Access Compliance Report

Public Rights-of-Way

(Curb Ramps)

Intersection ID: 3064	Main Street: BLACK_MAPLE_AV	Cross Street: HEDGE_MAPLE_RD	Location:	N
ADA ID: A6B188DAC65F	Ramp Type: Perp	Initial Pass/Fail: Fail	Overall Compliance: No	Severity Score: 8.75
Codes/Mitigation Info/Possible Solution		Field Measurements/Component Compliance

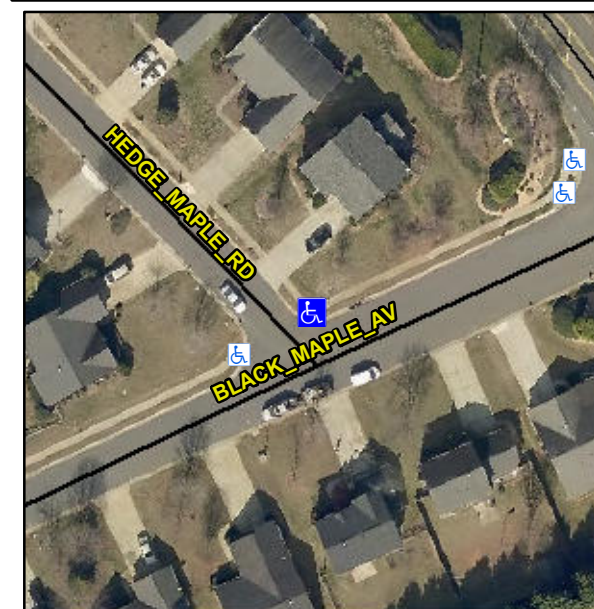
R304.5.1

Compliance	Description	Data	Compliance	Description	Data
N/A	Ramp Length (in)	95.5	Yes	Ramp Slope (%)	5.3
No	Ramp Width (in)	45.0	Yes	Ramp XSlope (%)	1.2
N/A	Flare Type LT	N/A	N/A	Flare Type RT	N/A
N/A	Flare Slope LT (%)	N/A	N/A	Flare Slope RT (%)	N/A
N/A	Flare Traversable LT?	N/A	N/A	Flare Traversable RT?	N/A
N/A	Landing Length (in)	N/A	N/A	DWS Provided?	N/A
N/A	Landing Width (in)	N/A	N/A	DWS Contrast?	N/A
N/A	Landing Slope (%)	N/A	N/A	DWS Length (in)	N/A
N/A	Landing X Slope (%)	N/A	N/A	DWS Full Width?	N/A
N/A	Landing Curb? (Y/N)	N/A	N/A	DWS Offset (in)	N/A
N/A	Shared Landing?	N/A			
N/A	Gutter Ponding?	N/A	N/A	Gutter Slope (%)	N/A
N/A	Gutter Lip Ht (in)	N/A	N/A	Gutter X Slope (%)	N/A
N/A	Painted X Walk1?	No	N/A	Painted X Walk2?	N/A
	X Walk 1 Direction	To SW		X Walk 2 Direction	N/A
N/A	X Walk 1 Width (in)	N/A	N/A	X Walk 2 Width (in)	N/A
	X Walk 1 Slope (%)	0.4		X Walk 2 Slope (%)	N/A
	X Walk 1 X Slope (%)	2.0		X Walk 2 X Slope (%)	N/A

Remove & Replace Entire Ramp.
